**COUNTY OF SAN MATEO
PLANNING AND BUILDING DEPARTMENT**

TO: Planning Commission

SUBJECT: Consideration of a Coastal Development Permit (CDP) and Design Review Permit, pursuant to Sections 6328.4, and 6565.3 of the Zoning Regulations, to allow the construction of a 418 sq. ft., single-story addition to an existing 1,978 sq. ft. single-family residence on a legal 5,488 sq. ft. parcel in the Moss Beach area of the unincorporated San Mateo County. The project involves only minor grading and no tree removal. The project is appealable to the California Coastal Commission.

County File Number: PLN 2022-00010 (Moldovan)

**EXTERIOR
 VIEWS**

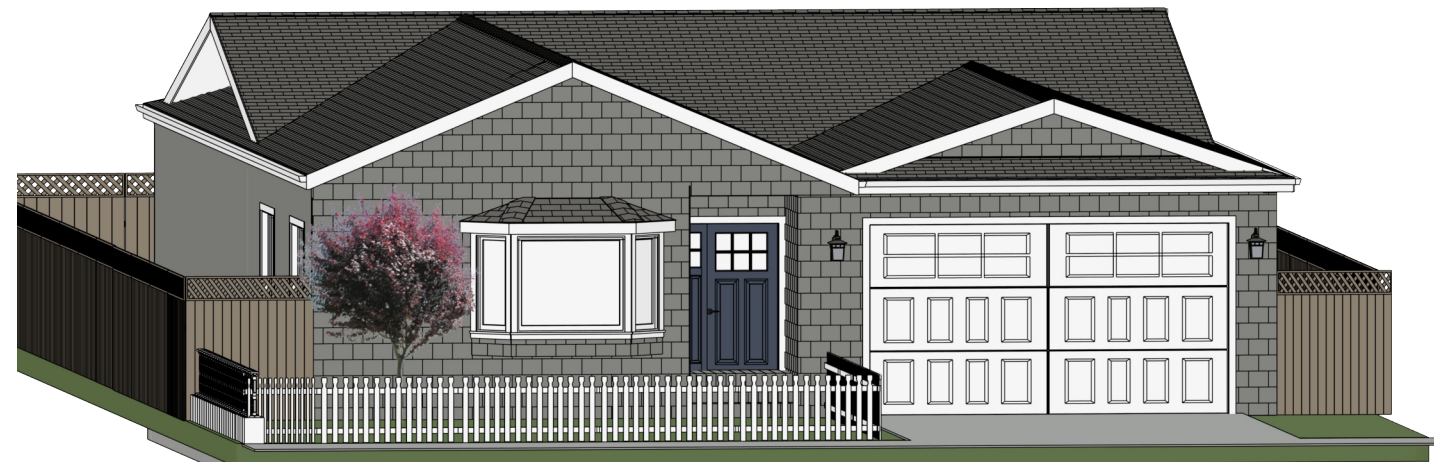
- a. Add “Bay Window” to the front of proposed addition, which shall be the same size as the originally proposed window. Remove eyebrow roof gable at new addition only.

2. The applicant shall indicate the following on plans submitted for a building permit, as stipulated by the Coastside Design Review Committee:
- a. Add "Bay Window" to the front of proposed addition, which shall be the same size as the originally proposed window. Remove eyebrow roof gable at new addition only.

△⁴ Removed shed roof on left and added bay window
